UNITED STATES PATENT AND TRADEMARK OFFICE

APPLICATION NO.	FILING DATE	FIRST NAMED INVENTOR	ATTORNEY DOCKET NO.	CONFIRMATION NO.
10/822,572	04/12/2004	Shawn L. Lloyd	ITL.1113US (P18785)	2638

Office Action Summary

DETAILED ACTION

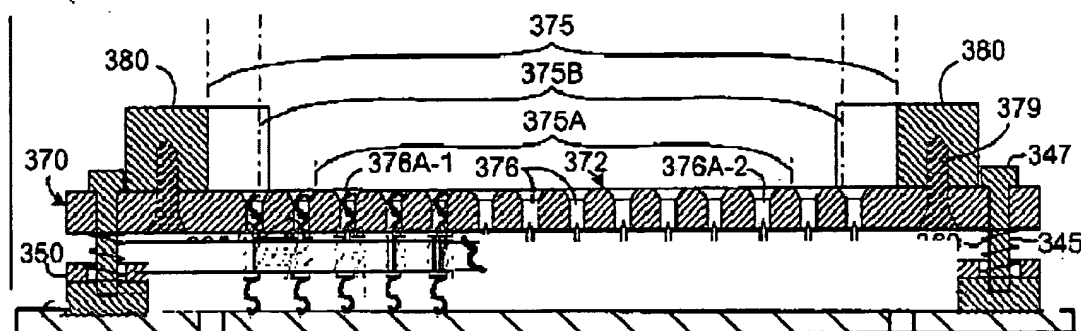
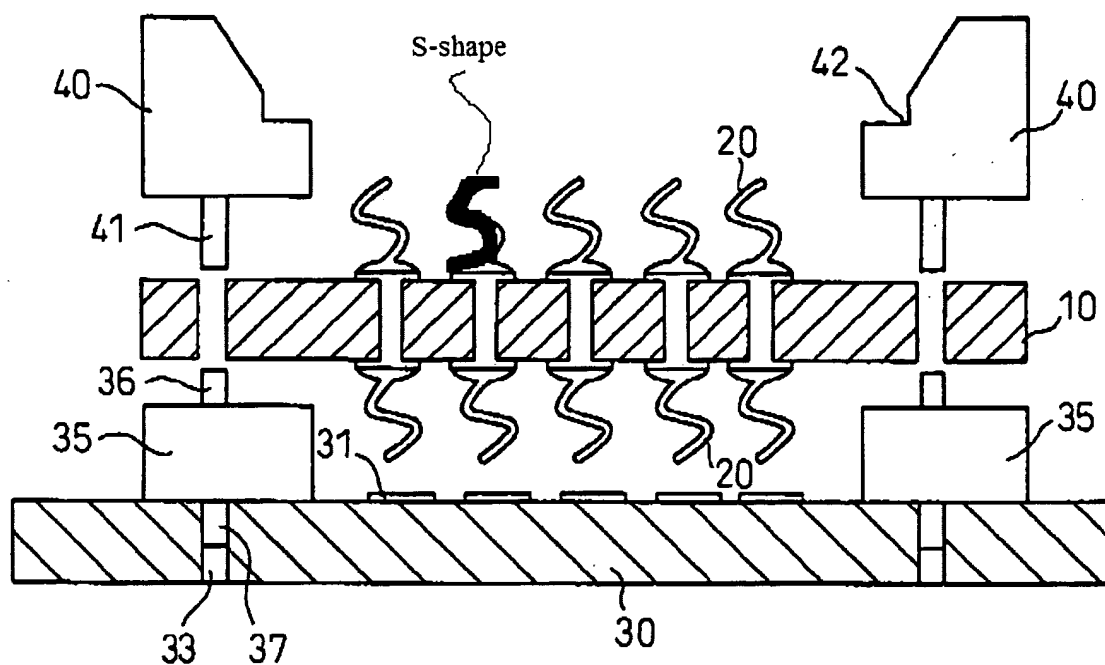
Higashi shows spring contacts 20 (see examiner's figure) are S-shaped and the combination of Hornchek and Higashi is considered to be adapted to make wiping electrical contact with a solder ball inserted into the aperture (see examiner's figure).

Further, it would have been obvious to one of ordinary skill in the art at the time the invention was made to replace the mounting plate 350 with spring contacts 320 of Hornchek with the mounting plate 10 with the S-shaped spring contact 20 Higashi (see examiner's figure).

Higashi shows spring contacts 20 (see examiner's figure) are S-shaped and the combination of Hornchek and Higashi is considered to be adapted to make wiping electrical contact with a solder ball inserted into the aperture (see examiner's figure).

Further, it would have been obvious to one of ordinary skill in the art at the time the invention was made to replace the mounting plate 350 with spring contacts 320 of Hornchek with the mounting plate 10 with the S-shaped spring contact 20 Higashi (see examiner's figure).
